A-2-MAR-25-0040 (SLADDEN-MCELROY SFD)

EX PARTE COMMUNICATION DISCLOSURE FORM

Re: 66 Altura Ave., Bolinas
Bluff Setback and Erosion Issues

EXHIBIT " B "
DETAIL STUDY OF
"HINGE POINT" / TOP OF BLUFF
& PERTINENT SETBACKS

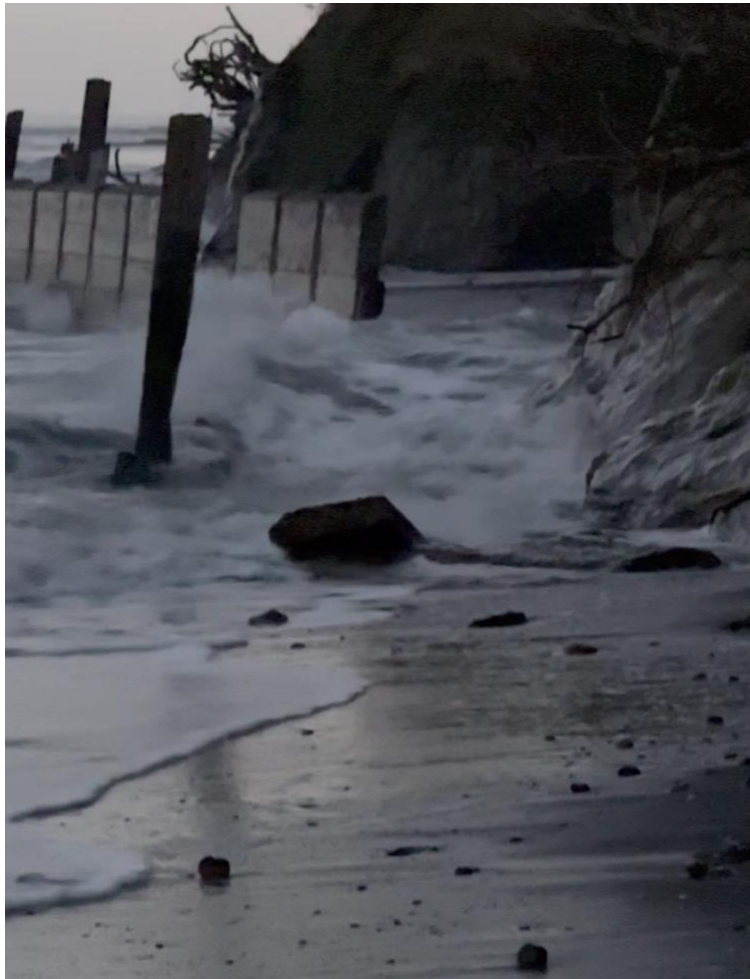
The staff report and proposed resolution assert that a 65-foot setback from the bluff top is appropriate, and that the project would be set back by 68 feet. Both assertions are wrong. The proposed project would violate the setback requirements of the LCP.

As an initial matter, the proposed project would actually only be setback from the current top of the bluff by about 60 feet. The applicant relies on LIDAR data from 2019 to establish the top of the bluff, but significant additional sliding has occurred since then. LIDAR data gathered by Mr. Stoner this year, and analyzed by the surveyor Larry Stevens, establish that the proposed project would now be only *60 feet* from the current bluff top—well within *any* required setback. See **Exhibit 2 and Exhibit 3**.

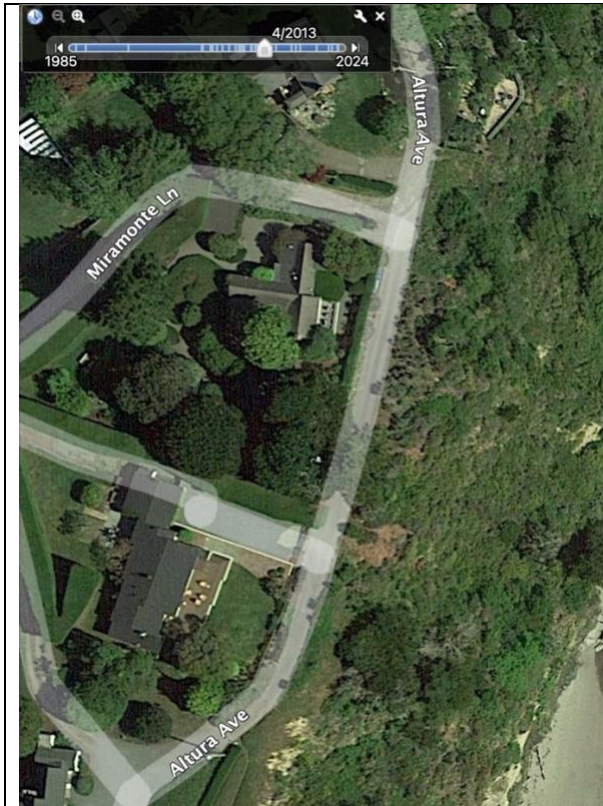
The staff report also does not address that, in areas where “vigorous sliding” is taking place, the LCP requires an additional 15 meters of setback. (Zoning Code § 20.64.060.B(1).) In just the previous 13 years, vigorous and repeated slides are apparent in Google Earth imagery:

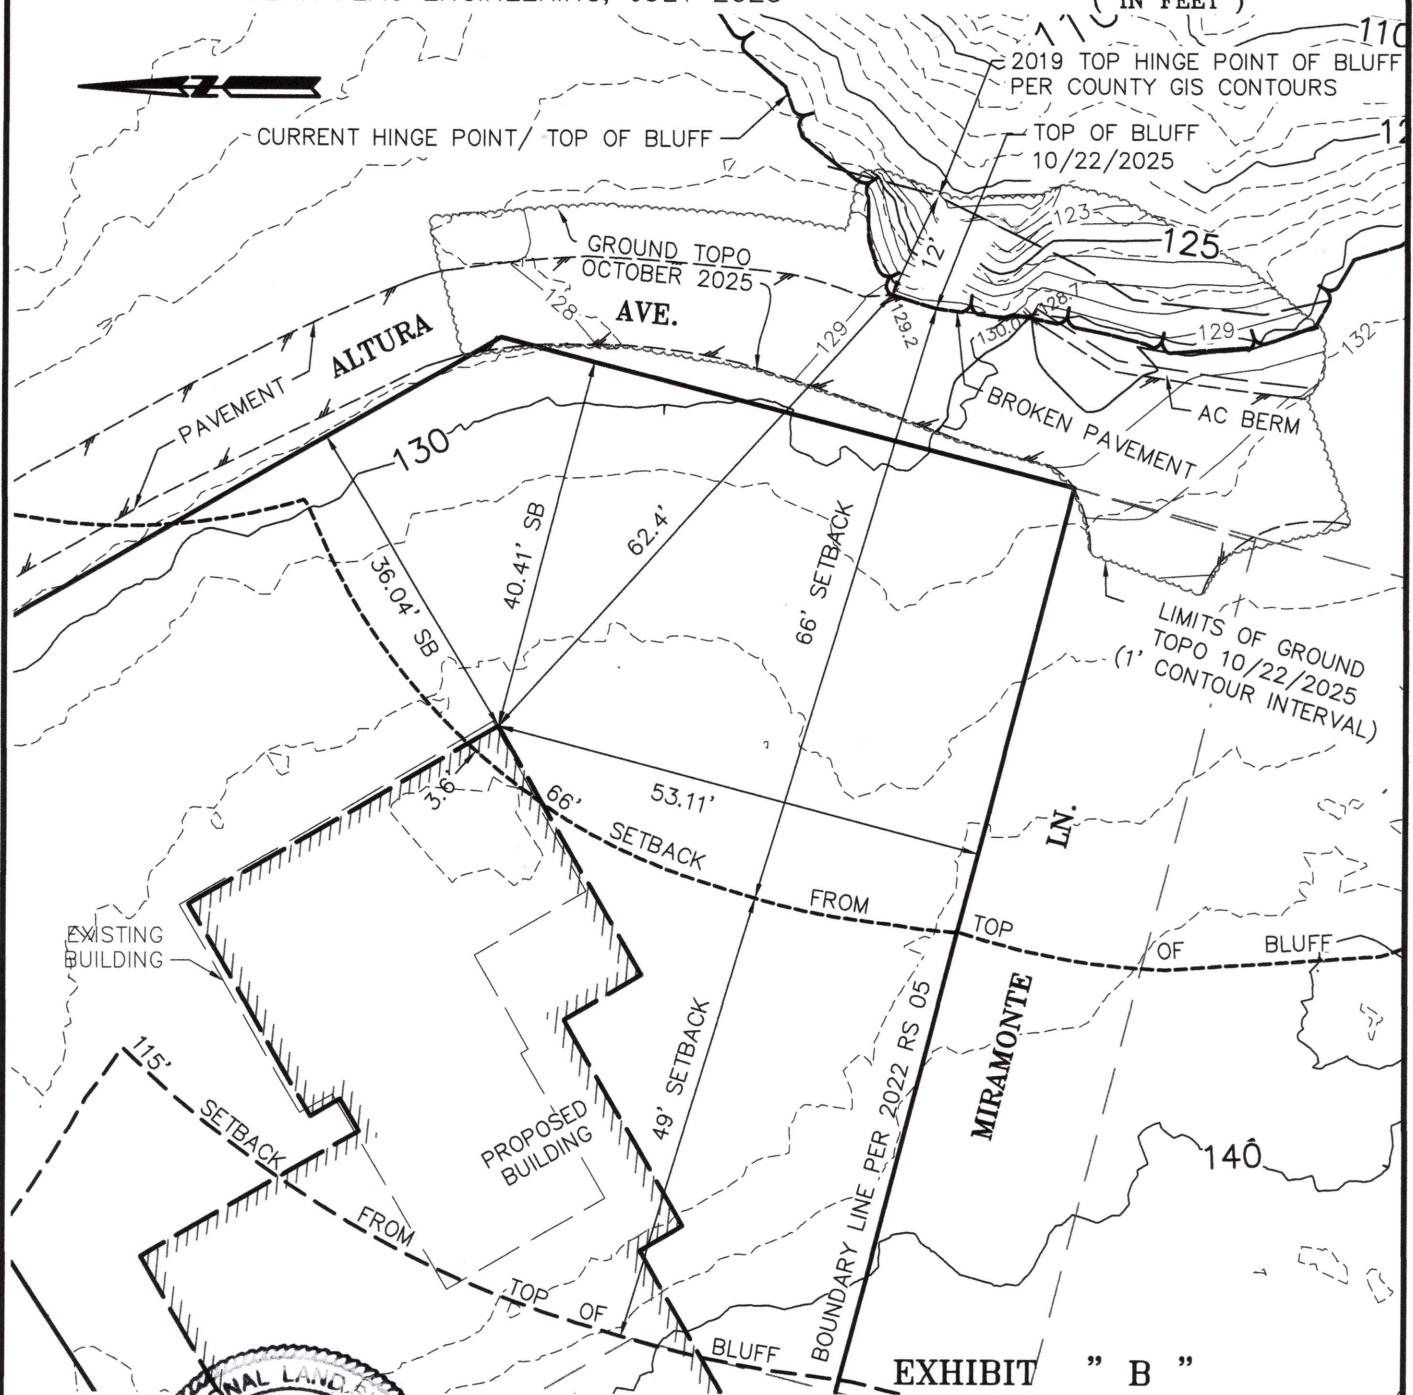
- The Top of Bluff has migrated approximately 12 feet landward since 2019 based on comparison with Marin County GIS contours.
- The current toe of the bluff is being actively undermined due to failure of the historic seawall along the base.
- The measured 62.4-foot setback is less than the 66-foot LCP minimum.
- The seawall is deteriorated, allowing direct wave attack and accelerating erosion.
- No recent studies have been mentioned regarding the toe of bluff erosion which gives support to the hillside, the seawall failures at the prior toe of the hillside and sea level rise. The reports give mention that many of these slides occur because of the erosion at the bluff toe.

1. The current Top of Bluff lies approximately 12 feet inland from the 2019 County GIS bluff line.
2. The proposed residence is set back 62.4 feet from the Top of the Bluff, at least 3.6 feet, and up to 51.6 feet, short of the required LCP setback.

3. The toe of the bluff is actively eroding, consistent with 20–24 inches/year retreat documented in regional studies and far faster than the applicant's and staff report's assumptions.

4. The County GIS and plan-based setbacks are not survey-grade and cannot satisfy statutory or LCP accuracy requirements.
5. Revised site planning is recommended to achieve compliance with the LCP's setback requirements and ensure stability over the design life of the structure.
